SUBJECT: ATLAS MINERALS URANIUM MILL

REPORT ON ATLAS MINERALS URANIUM MILL TAILINGS DAM INSPECTION AND EVALUATION

FCPF:RAS
40-3453
SUA-917, Amendment No. 4

DESIGN CRITERIA FOR IMPROVEMENTS
OF TAILINGS DISPOSAL SYSTEM AT
ATLAS MINERALS MILLING OPERATIONS,
MOAB, UTAH

Western Embankment Section

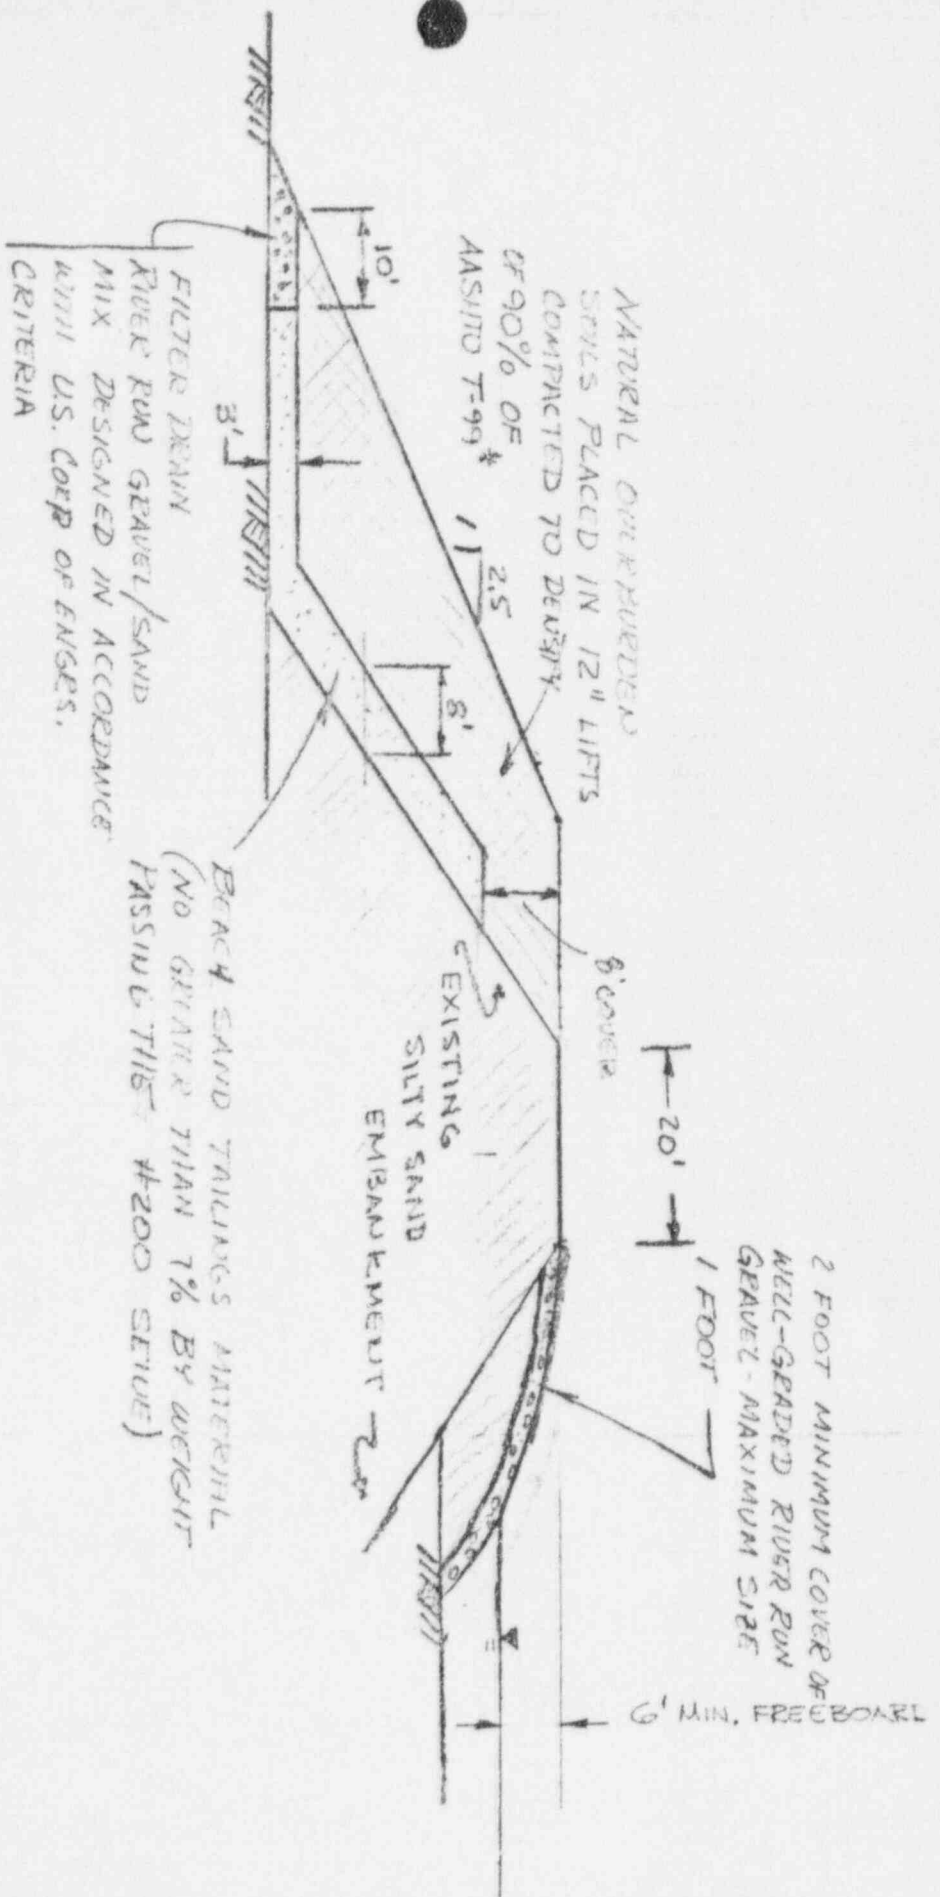
Along the western embankment area of the tailings pond the design criteria for improvements are shown on Figure 1 and include the following:

1. A minimum freeboard requirement of 6 feet must be met at all locations.
2. A 2-foot minimum cover of rip-rap material is required for wave-erosion protection over the entire upstream slope. The material will consist of well-graded river run gravel with pieces of a maximum size of one foot.

3. A crest width of 20 feet must exist at all embankment sections.
4. Beach sand tailings will be placed against the upstream slope and along the natural ground surface adjacent to the existing toe of embankment slope with the dimensions as shown on Figure 1. The tailings fill material will have particle sizes such that there will be no greater than 7% by weight passing the No. 200 sieve.

5. Filter material of river run gravel with gradation sizing designed in accordance with U.S. Corp of Engineers criteria. The dimensions of placement will be as shown on Figure 1.

6. Overburden material will be placed over the beach sand with minimum cover of 8 feet. The overburden will be of natural near-site sand and silt and will be placed to the dimensions shown on Figure 1. The fill should be placed in 12 inch lifts (loose state) and compacted to a dry density of at least 90% of the maximum density as determined by the AASHTO T-99 method of compaction.

Figure 2

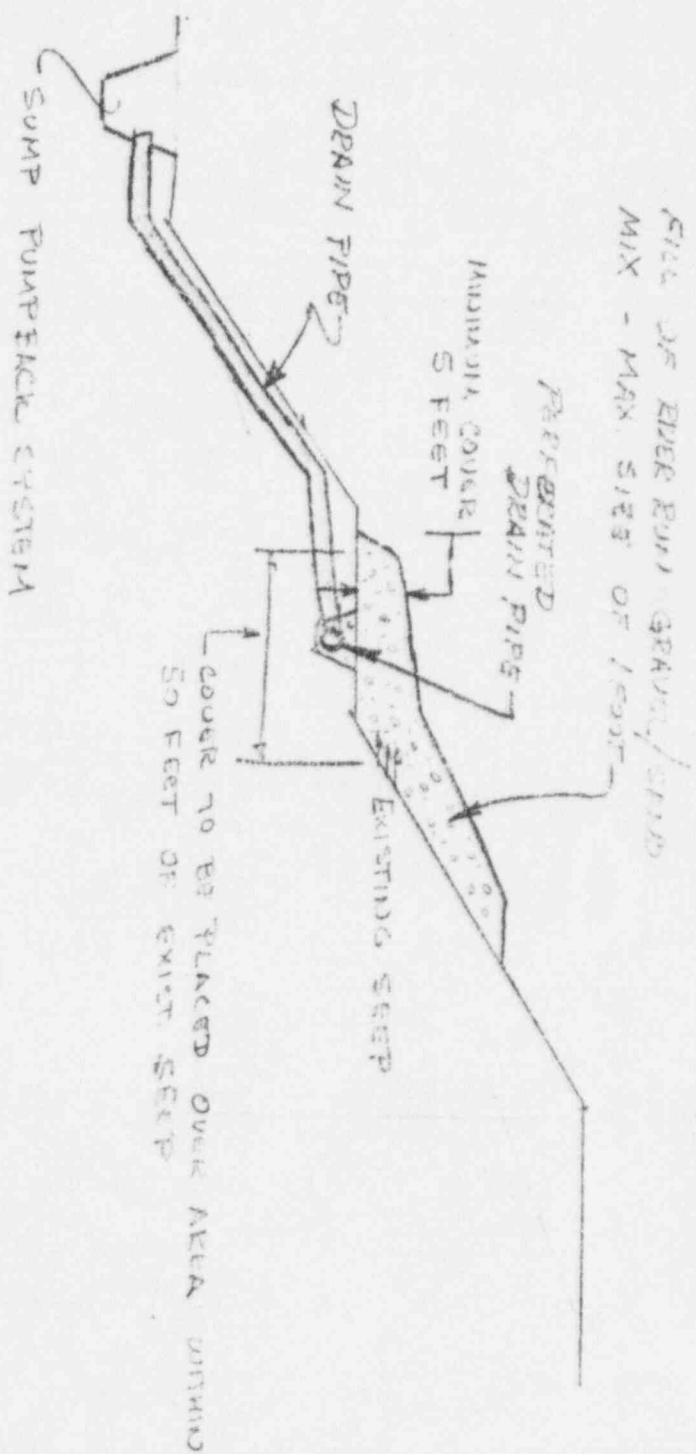
Construction of an overburden fill will be placed over the seepage area located at the north embankment toe. The construction requirements and dimensions are shown on Figure 2 and include the following:

1. An overburden fill of well-graded river run gravel will be placed over the seep area a distance of at least 50 feet in all directions from the seep. The minimum fill thickness of 5 feet will be met over the above stated area. The maximum particle size of the material will be one foot.
2. A perforated drain pipe will be placed as shown on Figure 2 and drained by pipe to a sump pumpback system located near the downstream toe of slope.
